# Discussion of Modifications to 802.1AS-2020 to Resolve Maintenance Items 369, 371, and 372

*IEEE 802.1 Maintenance TG*  
2024.09.10

Figure 12-7. TimeReceiver state machine

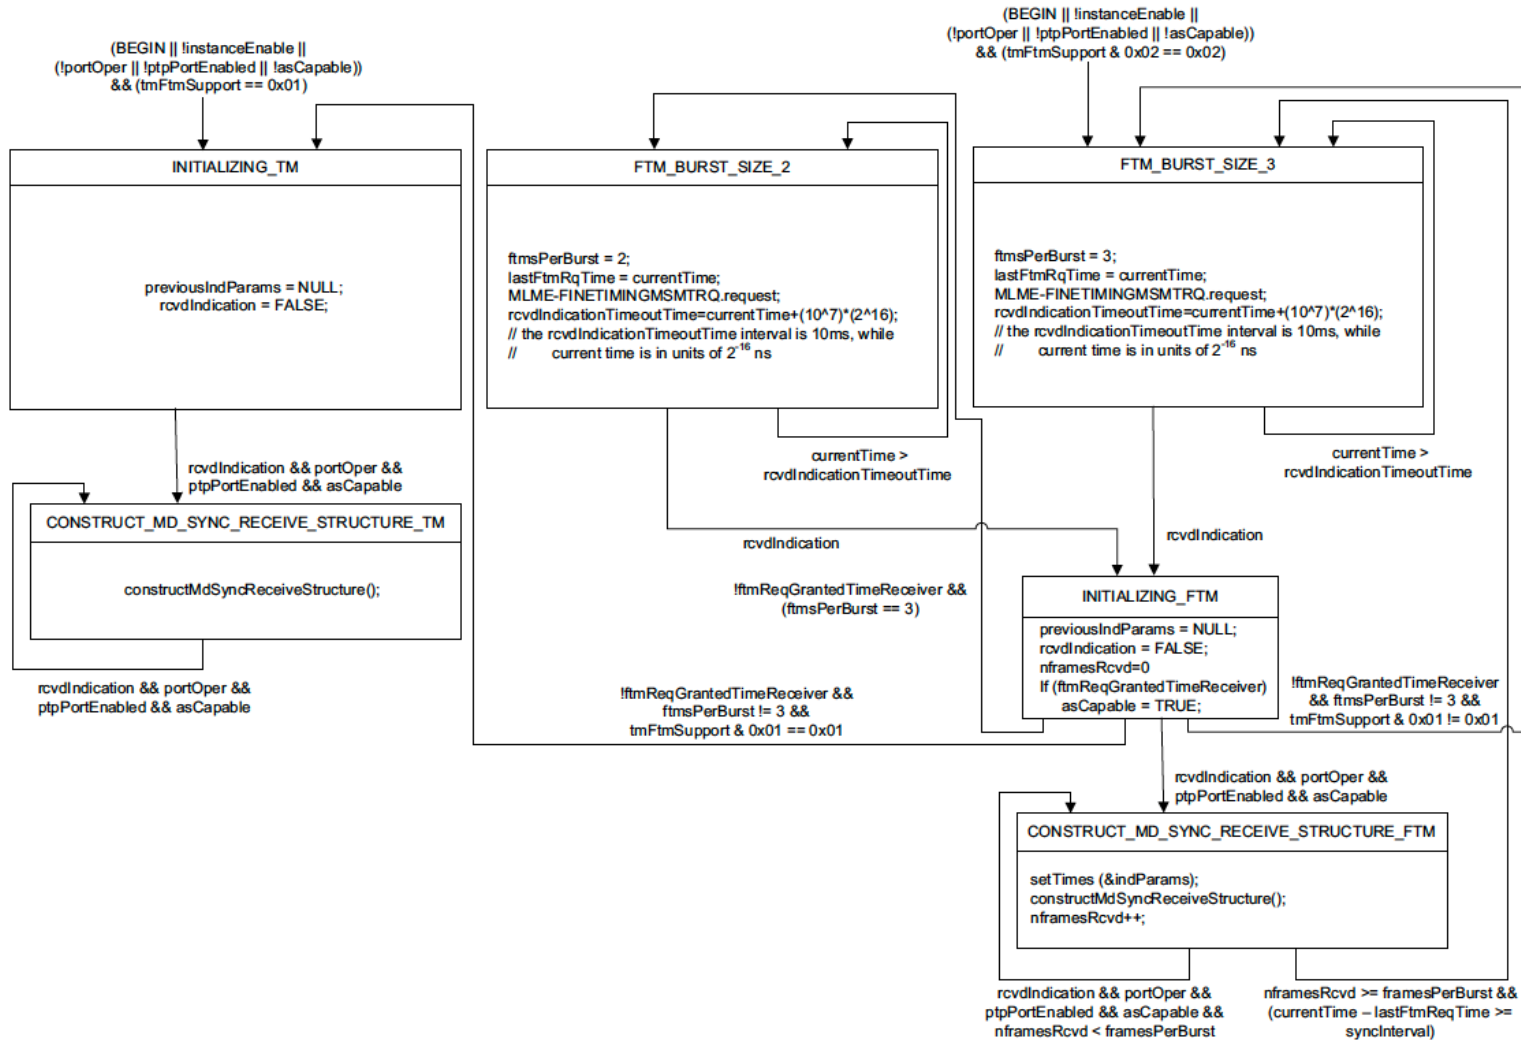
There is a mix of names in the slave state machine (Fig. 12-7) . It seems that "ftmsPerBurst" and "framesPerBursts" is used for the same variable.

In Fig. 12-7 change "framesPerBursts" to "ftmsPerBurst".

- ❑ As indicated in the maintenance item rationale for revision, both `framesPerBurst` and `ftmsPerBurst` are used in Figure 12-7
- ❑ `ftmsPerBurst` is defined in 12.5.2.3.8 as a local variable for the media-dependent `TimeReceiver` state machine:

- ❑ `framesPerBurst` is not explicitly defined; however, it is used in the following places:
  - Figure 12-7, in conditions for transitions leading out of the `CONSTRUCT_MD_SYNC_STRUCTURE_FTM` state
  - A parameter of the `initReqParamsDot11TimeTransmitter` structure
  - A parameter of the `initReqParamsDot11TimeReceiver` structure

- ❑ In the normal case, where the request is granted, this is the same as `ftmsPerBurst` of 12.5.2.3.8 of 802.1AS-2020, and was intended by the stand-alone local variable “`framesPerBurst`” in Figure 12-7
- ❑ Based on this discussion, the stand-alone local variable “`framesPerBurst`” in Figure 12-7 should be changed to “`ftmsPerBurst`”
- ❑ In addition, for consistency the nomenclature used in 802.11-2020, the instances where “`framesPerBurst`” is used as the name of members of the `initReqParamsDot11TimeTransmitter` and `initReqParamsDot11TimeReceiver` structures can be changed to “`ftmsPerBurst`”

- Change “framesPerBurst” to “ftmsPerBurst” in the conditions exiting the CONSTRUCT\_MD\_SYNC\_STRUCTURE\_FTM state of Figure 12-7
- Change “framesPerBurst” to “ftmsPerBurst” in the following places:
  - Figure 12-6 (2 places, where it is a member of the structure initReqParamsDot11TimeTransmitterB)
  - 12.5.1.4.5, fourth line of the function initRequestWaitConfirm(), where it is a member of the structure initReqParamsDot11TimeTransmitterB
  - 12.5.2.4.4, ninth line of the function constructMdSyncReceiveStructure(), where it is a member of the structure initReqParamsDot11TimeReceiver

Figure 12-2—Fine Timing Measurement procedure for IEEE 802.11 links

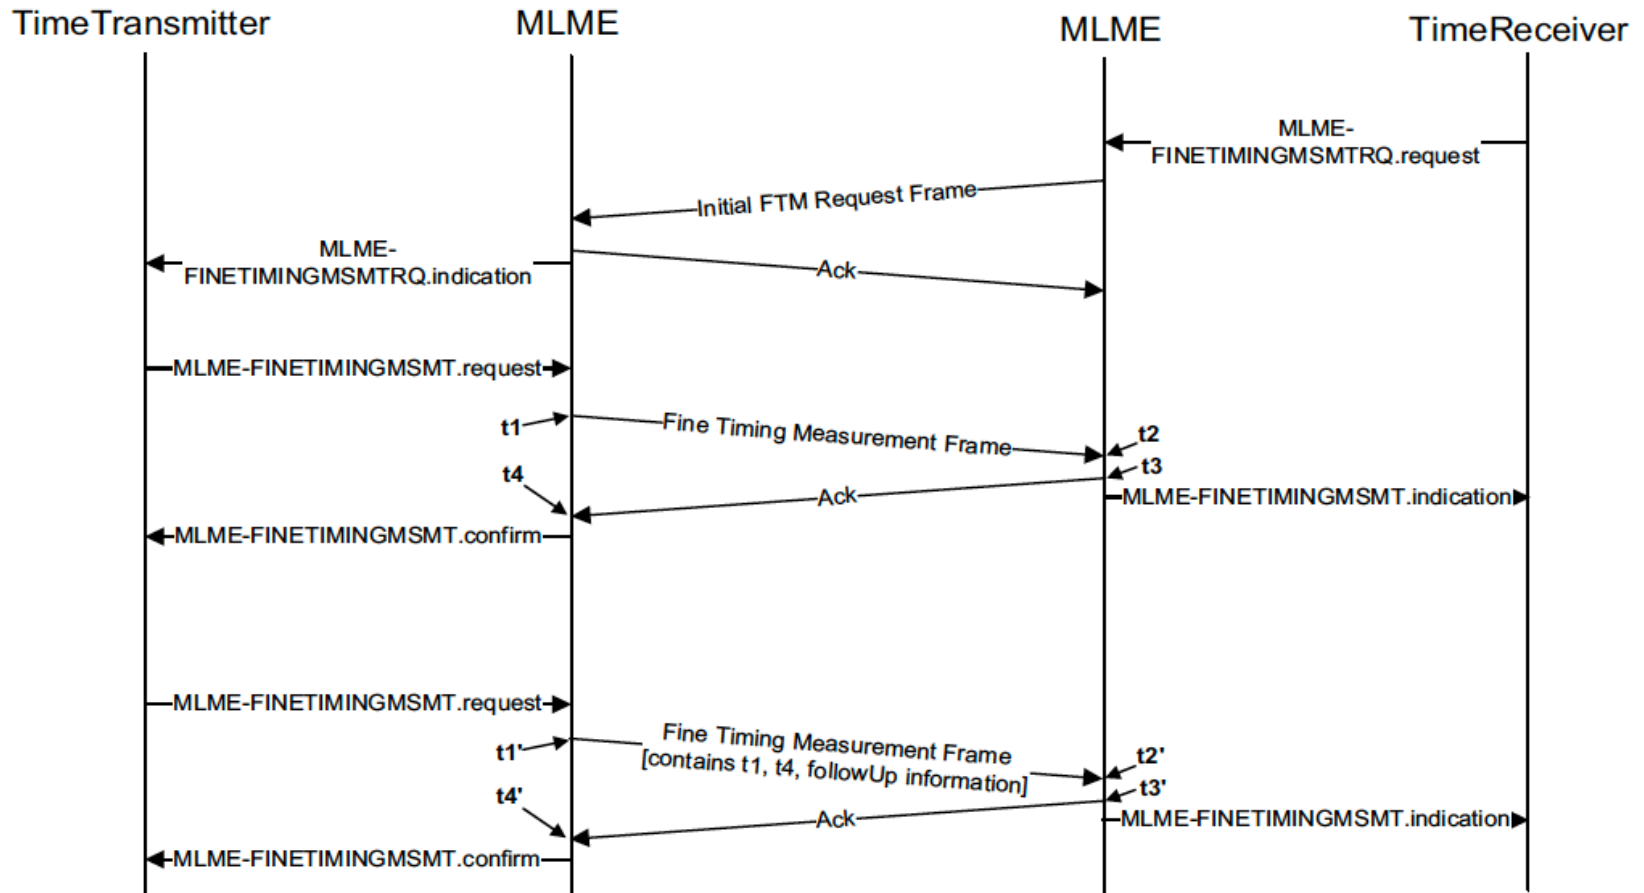
- ❑ It is convenient to discuss maintenance item 372 prior to discussing item 371
- ❑ Subclause 12.5.2.3.7 states:
  - **12.5.2.3.7 initReqParamsDot11Slave:** A structure whose members contain the values of the fields of an MLME-FINETIMINGMSMTRQ.indication primitive.
- ❑ Figure 12-2, copied on the next slide, shows the FTM procedure
- ❑ It is clear from this figure that TimeReceiver issues the MLME-FINETIMINGMSMTRQ.request primitive, and not the MLME-FINETIMINGMSMTRQ.indication primitive
  - The MLME-FINETIMINGMSMTRQ.indication primitive is issued by the MLME to the TimeTransmitter
- ❑ Therefore, this maintenance item can be resolved by accepting the proposed text, i.e.,

Change paragraph to: "A structure whose members contain the values of the fields of an MLME-FINETIMINGMSMTRQ.request primitive."
